Access Compliance Report

Public Rights-of-Way

(Curb Ramps)

Intersection ID: 11894	Main Street: N_BREVARD_ST	Cross Street: E_12TH_ST	Location: E
ADA ID: 17CE1362B6F1	Ramp Type: Perp	Initial Pass/Fail: Pass	Overall Compliance: No
Severity Score: 0.25			
Codes/Mitigation Info/Possible Solution		Field Measurements/Component Compliance

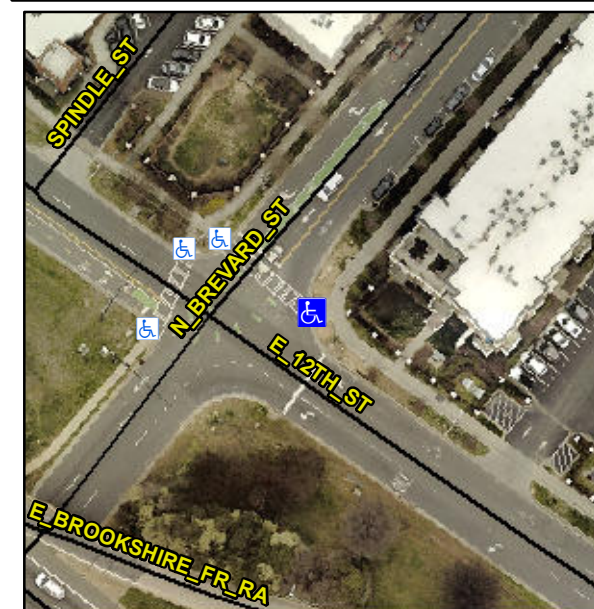
Not Found, R304.5.3, R305.2

Compliance	Description	Data	Compliance	Description	Data
N/A	Ramp Length (in)	115.0	Yes	Ramp Slope (%)	7.6
Yes	Ramp Width (in)	48.0	No	Ramp XSlope (%)	4.3
N/A	Flare Type LT	Sloped	N/A	Flare Type RT	N/A
N/A	Flare Slope LT (%)	3.3	Yes	Flare Slope RT (%)	10.0
N/A	Flare Traversable LT?	Yes	N/A	Flare Traversable RT?	Yes
Yes	Landing Length (in)	95.0	Yes	DWS Provided?	Yes
Yes	Landing Width (in)	48.0	Yes	DWS Contrast?	Yes
Yes	Landing Slope (%)	1.5	Yes	DWS Length (in)	24.0
No	Landing X Slope (%)	4.1	Yes	DWS Full Width?	Yes
N/A	Landing Curb? (Y/N)	No	No	DWS Offset (in)	2.5
N/A	Shared Landing?	Yes			
Yes	Gutter Ponding?	No	Yes	Gutter Slope (%)	1.2
Yes	Gutter Lip Ht (in)	0.0	No	Gutter X Slope (%)	4.6
N/A	Painted X Walk1?	Yes	N/A	Painted X Walk2?	N/A
	X Walk 1 Direction	To NW		X Walk 2 Direction	N/A
N/A	X Walk 1 Width (in)	87.0	N/A	X Walk 2 Width (in)	N/A
	X Walk 1 Slope (%)	0.3		X Walk 2 Slope (%)	N/A
	X Walk 1 X Slope (%)	3.5		X Walk 2 X Slope (%)	N/A

Yes	Ramp inside XWalk1?	Yes	N/A	Ramp inside XWalk2?	N/A
	Road Slope (%)	N/A	N/A	Clear Space?	Yes
	Road X Slope (%)	N/A	N/A	Clear Space to XWalk (in)	N/A
Yes	Any Obstructions?	No	Yes	Storm Grate/Utility Hazard?	No
	Obstruction Type			Storm Grate/Utility Type	
		N/A			N/A
			Yes	Surface Condition? (G/P)	Good

**Remove & Replace Entire Ramp.
Remove & Replace Gutter.**
